Introduction

These comments address Nova Scotia Power's August 2023 updated Action Plan and Roadmap items from its 2023 Evergreen Integrated Resource Plan (IRP).

NSPI Input Assumptions for Wind and Solar ELCC

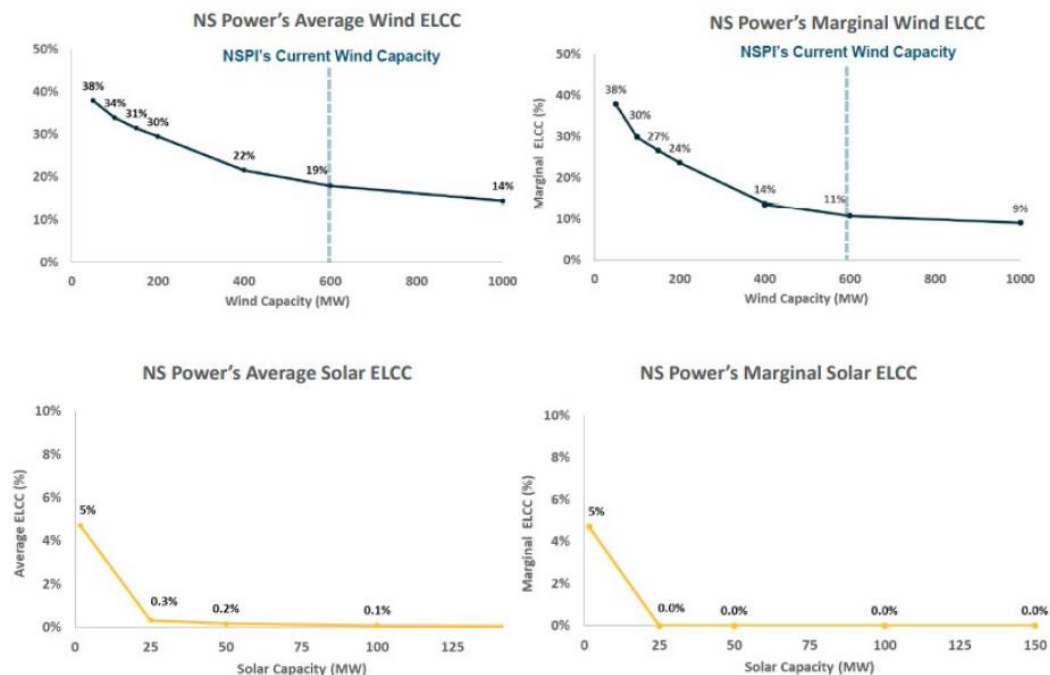
In our opinion, the pre-IRP capacity value study from 2019 (used in the 2020 IRP) does not fully capture the diversity effects that exist among battery energy storage, wind, solar, and demand response resources, and the capacity accreditation given to battery resources in this IRP update is too low. This affects the PLEXOS model optimization of capacity resources. Prior to the next IRP update, this study and the methods used to capture portfolio diversity should be updated. The new study should reflect the full measure of diversity effect considering all four of these resources, which are highly complementary in the provision of capacity. Demand response resources, or the equivalent capability of mitigating peak increases such as would be seen in the “hybrid peak mitigation” case, have a material influence on the peak load that might otherwise need a higher level of battery resources or other capacity resources to

maintain reliability. This would affect the portfolio ELCC and directionally would increase any ELCC factor attributed to the battery energy storage resources.

As noted, the battery energy storage ELCC profile used in this IRP update is a critical input value to the modeling that needs to be carefully re-examined in the next IRP or IRP update. The re-examination needs to be conducted in conjunction with an updated “portfolio ELCC” analysis that better considers the interactive effect of all four clean resources (wind, solar PV, battery energy storage, and demand response or peak load mitigation during winter peak periods). The current input assumptions used for ELCC for the portfolio of resources, while reflecting some level of diversity benefit,⁴ do not fully capture this critically important dynamic. The effect of this shortcoming is a failure of the capacity expansion portion of the modeling exercise to fully capture the interactive effect and thus produce a potentially sub-optimal output in the selection of capacity resources.

Slide 27 from NSPI’s input assumptions slide deck contains the only fully descriptive information on the ELCC considerations, in addition to what is contained in the 2019 Pre-IRP Planning Reserve Margin and Capacity Value Study.

Below is a reproduction of the ELCC components for wind and solar; and while the Capacity Value Study includes more information on the portfolio effect for battery storage and wind, and for solar PV and wind, there is no information available about a combined wind/solar/battery/demand response portfolio combination, and what its impact would be on the modeling under different ELCC input assumptions.
